**Molalla Planning Commission**

**6:30 PM, June 5, 2019**

- Cascade Center (File No. DRW-01-2019) – Site Design Review and Subdivision

**Figure 17-3.3-1 Approach Spacing**

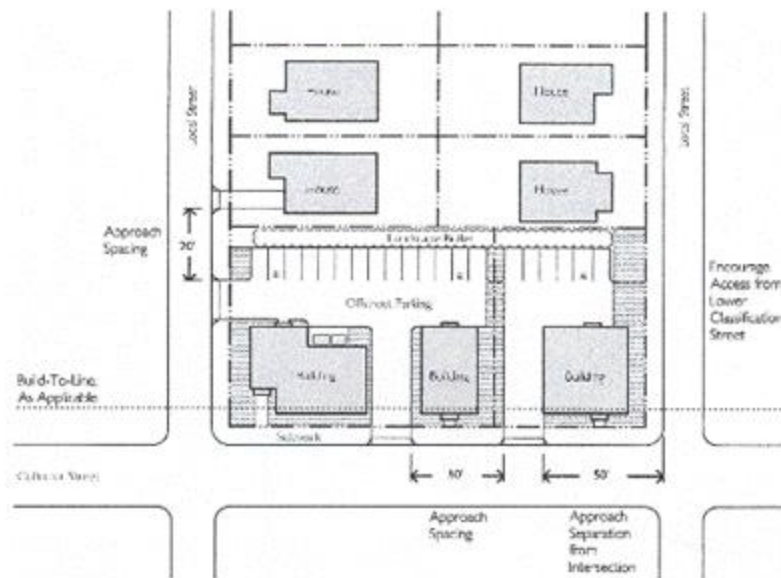
**FINDING:** Staff finds that the applicant’s proposal complies with the City’s approach separation from street intersections as the proposed driveway approach will be approximately 190-feet from the proposed Hwy. 211 / Leroy Ave. intersection. However, because Hwy. 211 is a State highway under ODOT’s jurisdiction, staff finds that the approach and proposed intersection will require review and approval by ODOT ultimately. Staff has already recommended that the Applicant/property owner be required to obtain all necessary ODOT review’s and approvals prior to beginning any construction.

**Figure 17-3.3-2 Vision Clearance**

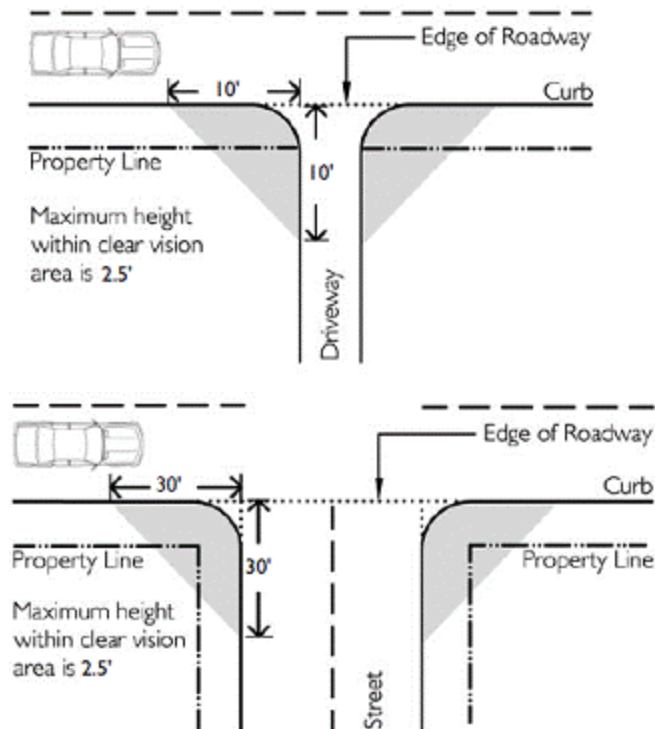
**FINDING:** Staff recommends, as a condition of any final approval, that the Applicant/property owner be required to continuously maintain all required Vision Clearance areas as shown in Figure 17-3.3-2.

SHEET NUMBER  
**P2.2**

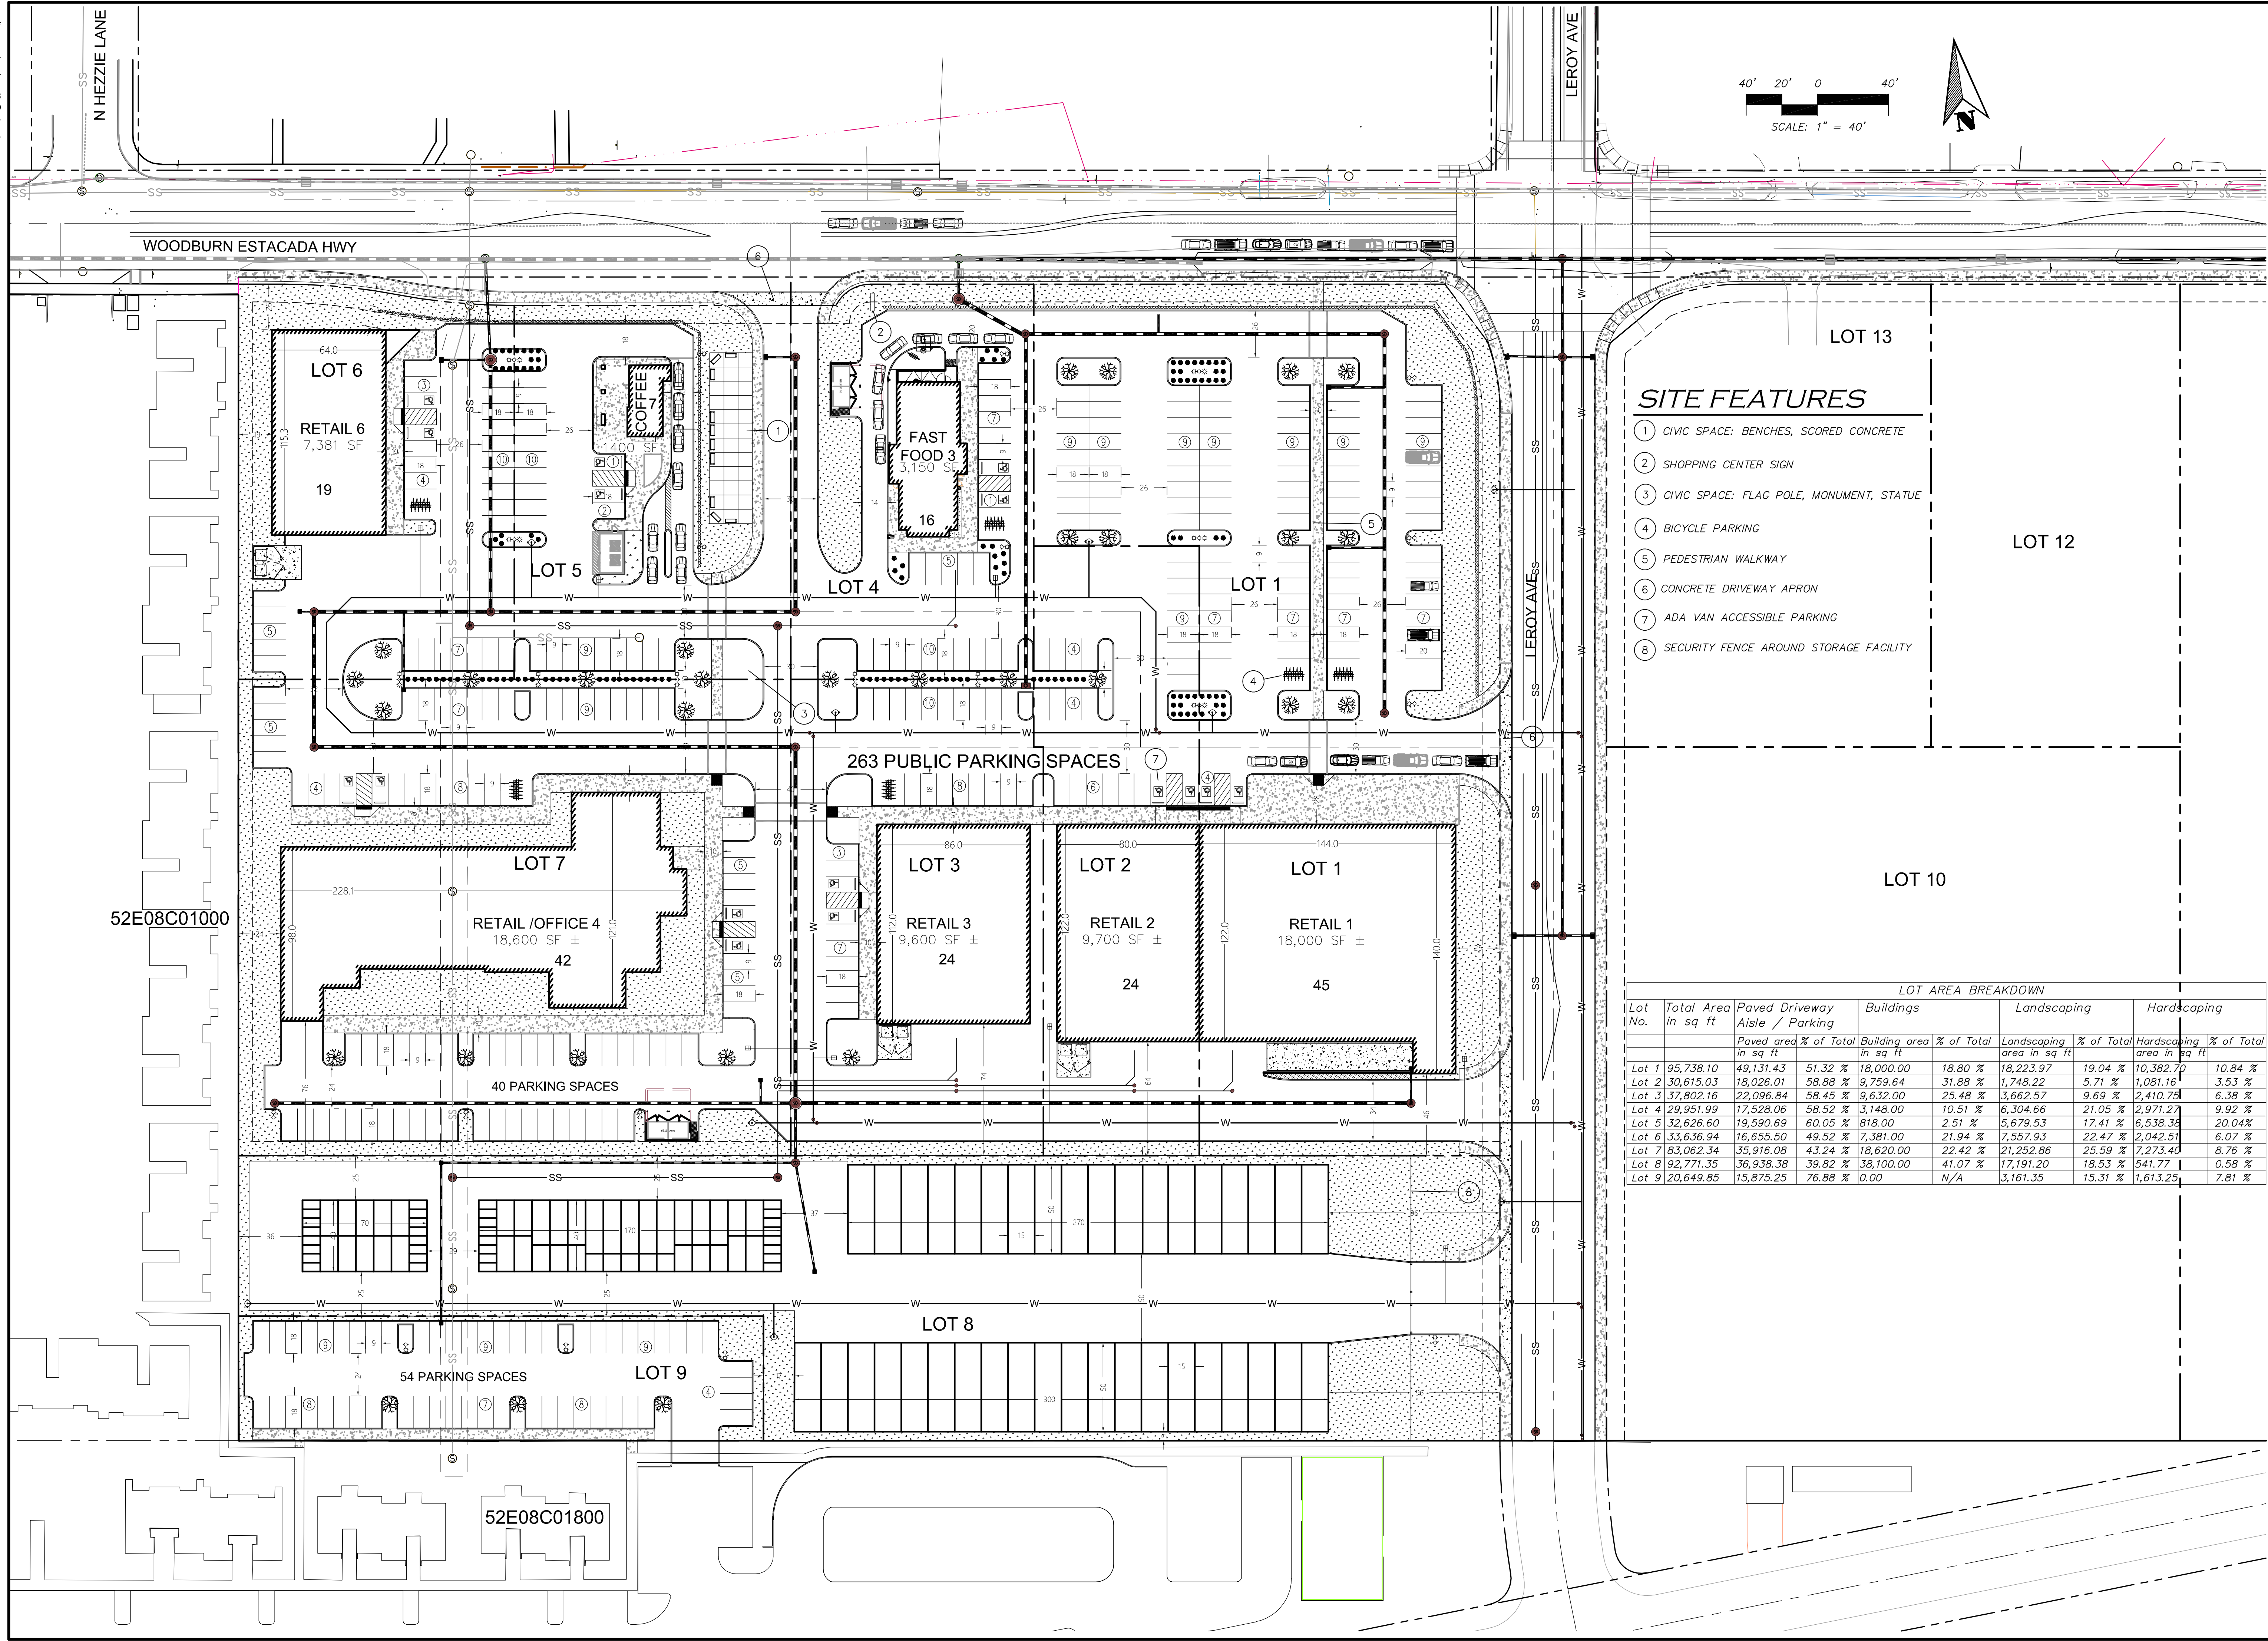
Access to public streets shall be limited to the accesses shown on Sheet P2.2 of the plans and attached to these conditions. Access spacing shall conform to the Transportation Systems Plan. The proposed width of accesses shall meet the Molalla Standard Specifications for Public Works Construction.
